## **Addendum # 1 Baseball Field Dugouts**

Date of Addendum: 3/16/17

**HENRY S. PARKER**  
DUGOUT  
Salisbury, MD

sk-3

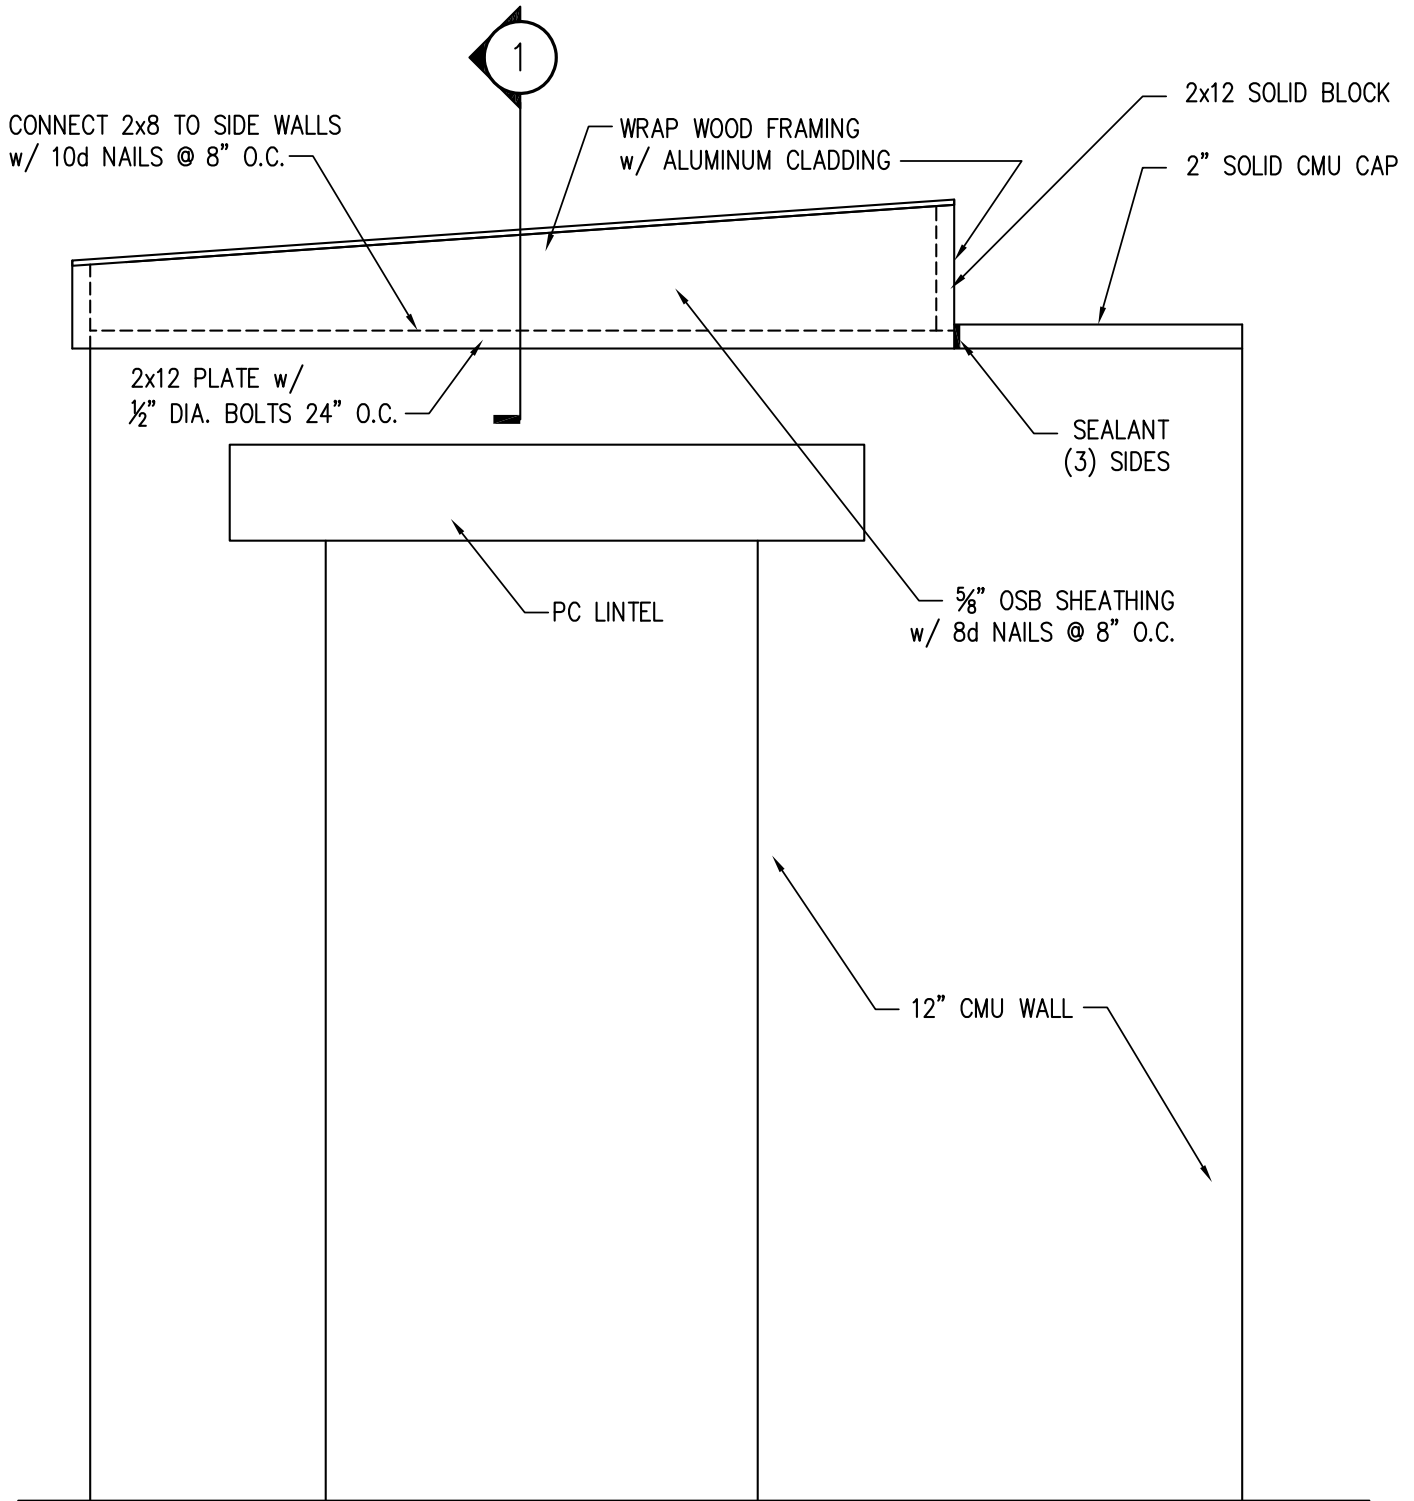
<b>Item</b>	<b>Questions and Answers</b>
3.1	Q. Will the EP Henry Block be Splitface? A. Yes
3.2	Q. The drawings show back wall with openings starting at 6' then continuing to 8' with CMU pilasters. Under General Requirements it calls for the back wall and one end wall to only go 4' high which is correct? A. Back wall is to be 4'
3.3	Q. If walls only go 4' high how do we cap them off? Just grout last course CMU solid? A. Solid cap. (As shown on additional drawing)
